**TOWN OF BROOKLYN
PLANNING AND ZONING COMMISSION
NOTICE OF PUBLIC HEARING**

SD 21-004: Resubdivision Application to create two building lots at Almada Drive and Paradise Drive (Assessor's Map 21, Lot 6), 104 acres, RA Zone, Applicant: Paul Lehto.

ENGINEERING PLAN REVIEW PERTAINING TO A 2-LOT RESUBDIVISION (ASSESSOR'S MAP 41, LOT 47) 40 ALMADA DRIVE BROOKLYN, CT (May 3, 2021)

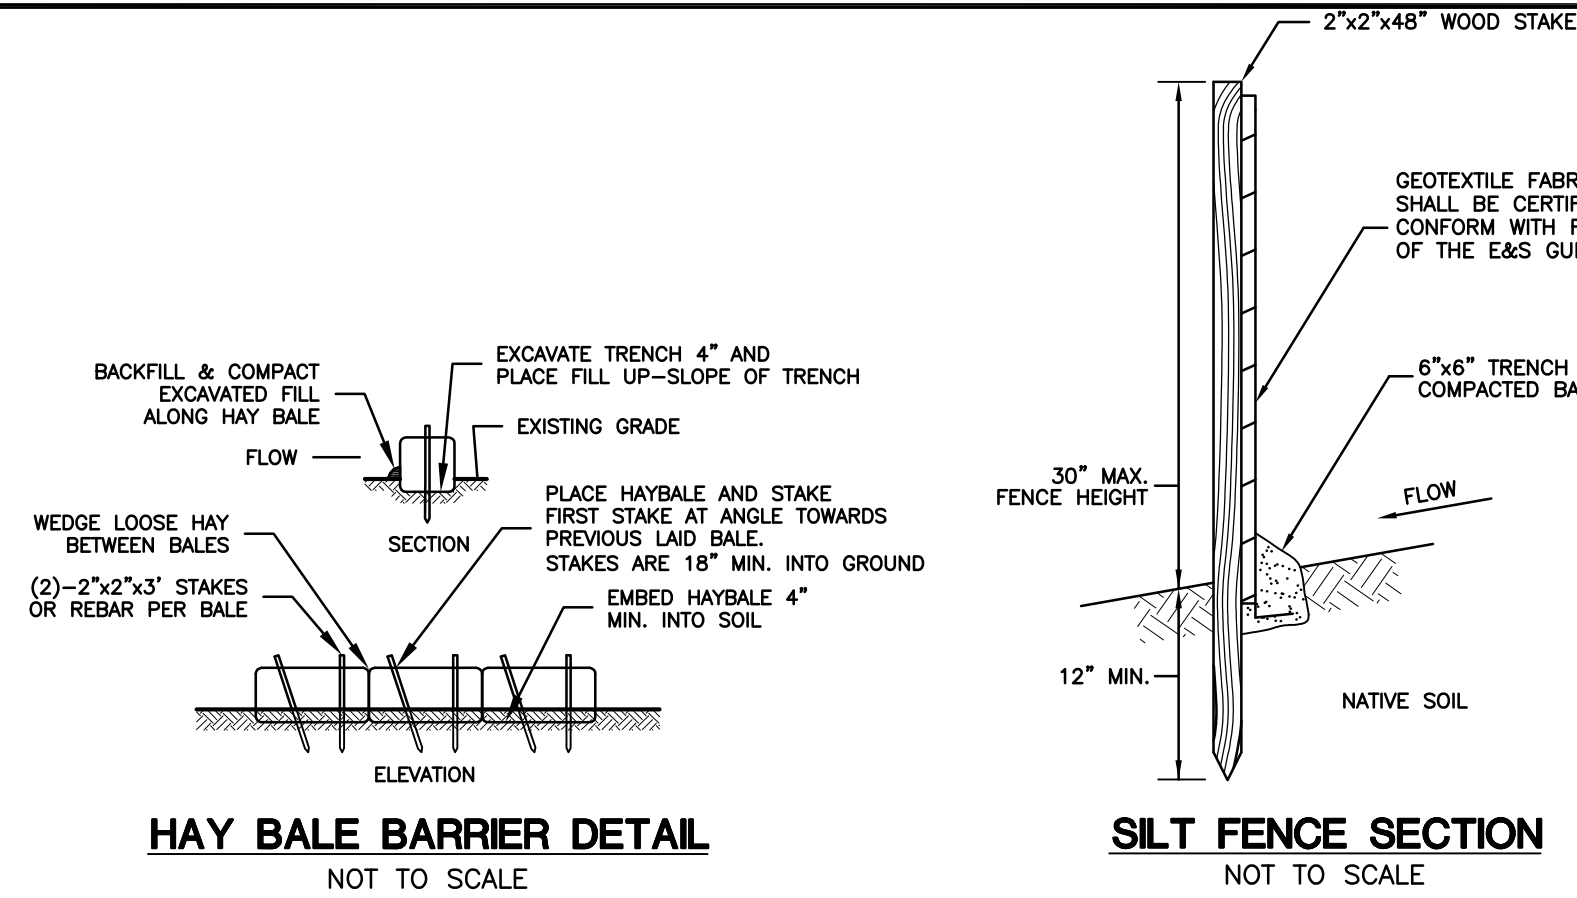
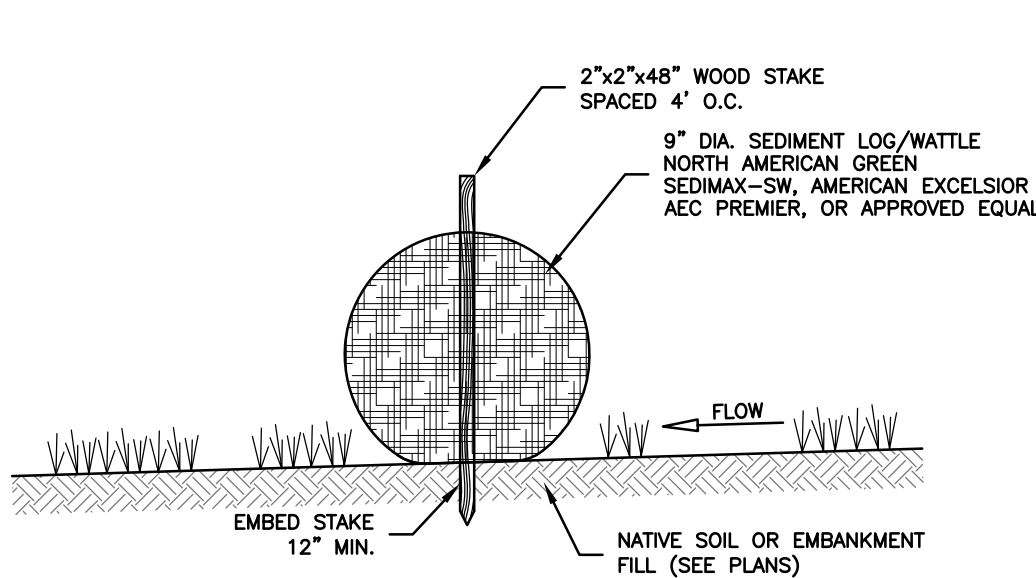
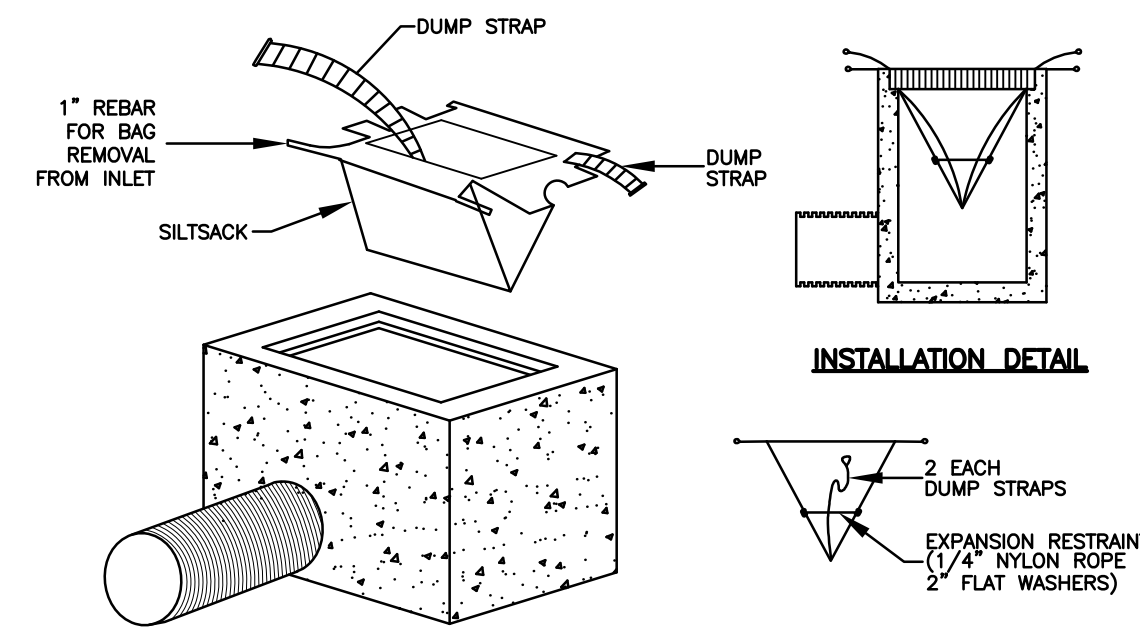
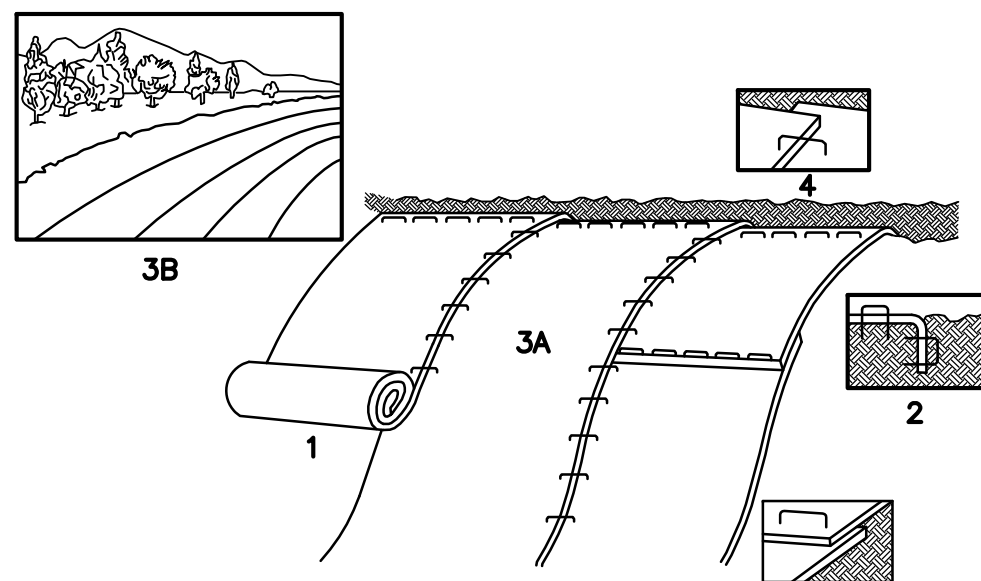
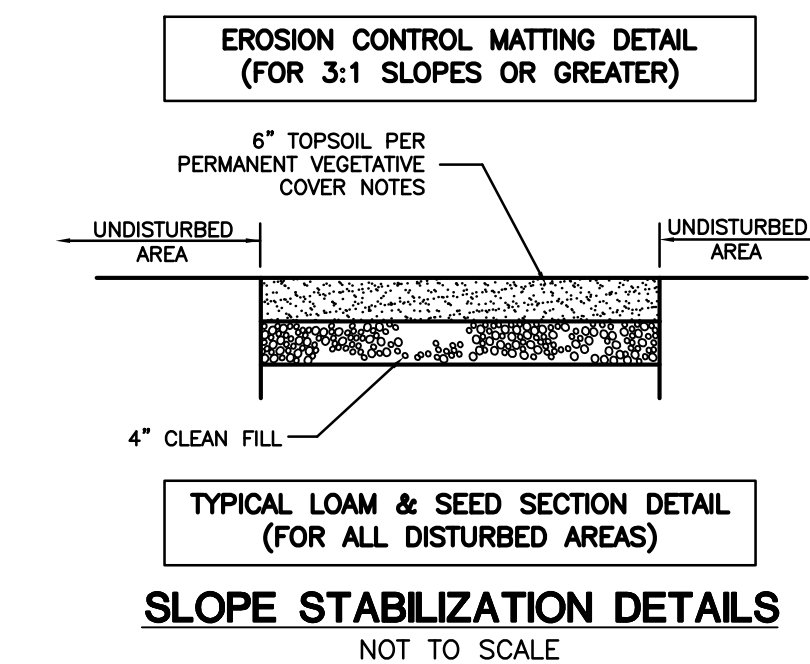
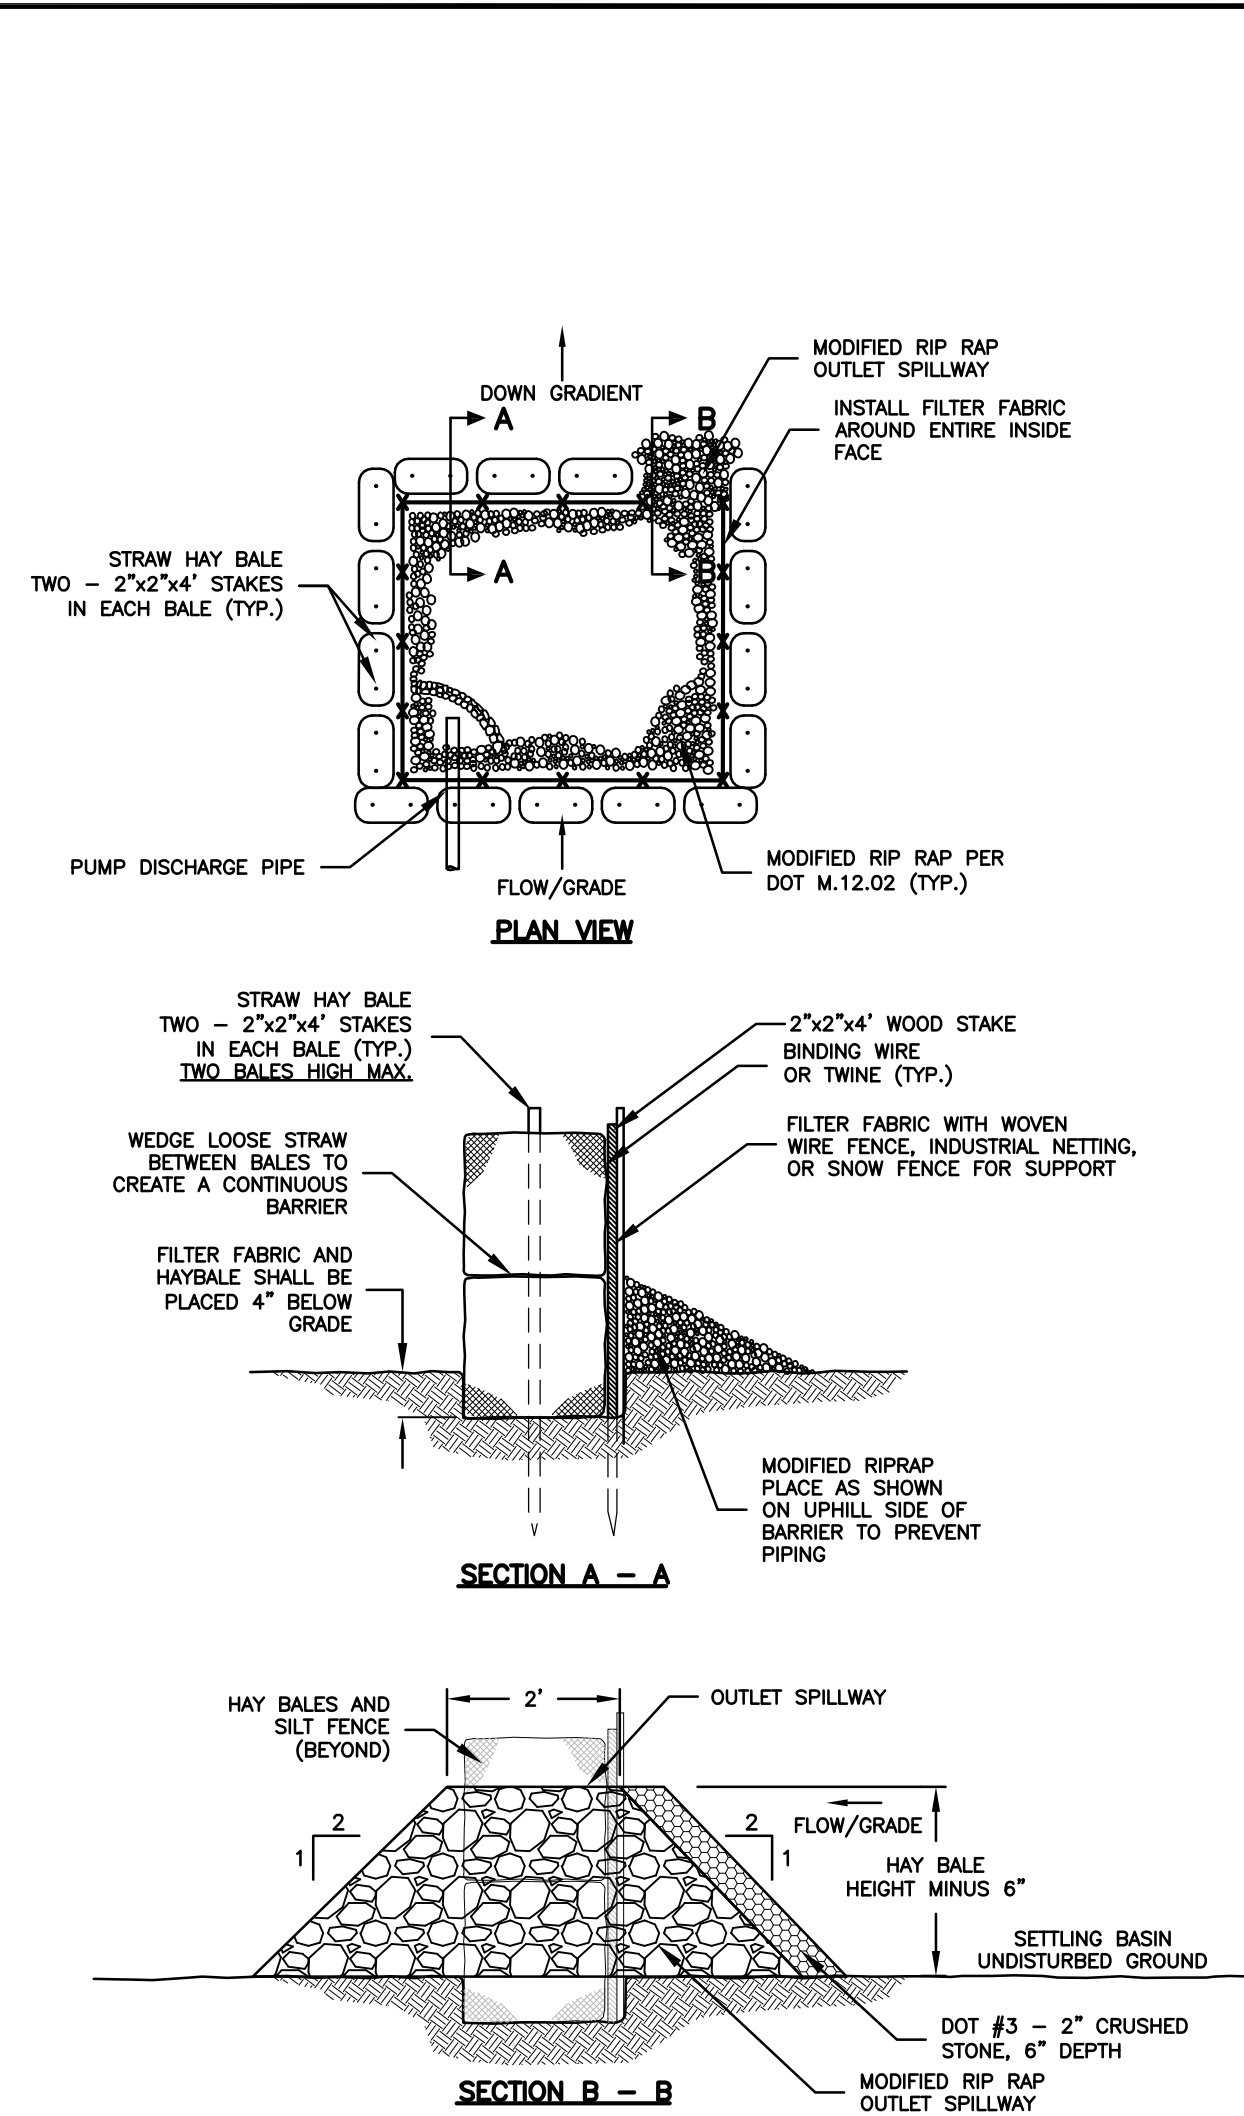
2. Note 2 under "Post Construction" it is stated that the *"Proposal is for the Town of Brooklyn to accept Almada Drive Extension as a town road that will be incorporated into the town MS4 Operations and Maintenance Program."* First of all, a designation of the Almada Drive Extension cannot be found on any plan submitted for review. Secondly, has this statement been agreed to by town staff and will the citizens of Brooklyn be the deciding body on whether or not this becomes a town road? If a privately owned road, MS4 can still be observed by its responsible party(s). This note needs an explanation as to why it appears here.

Post construction notes have been deleted from plan.
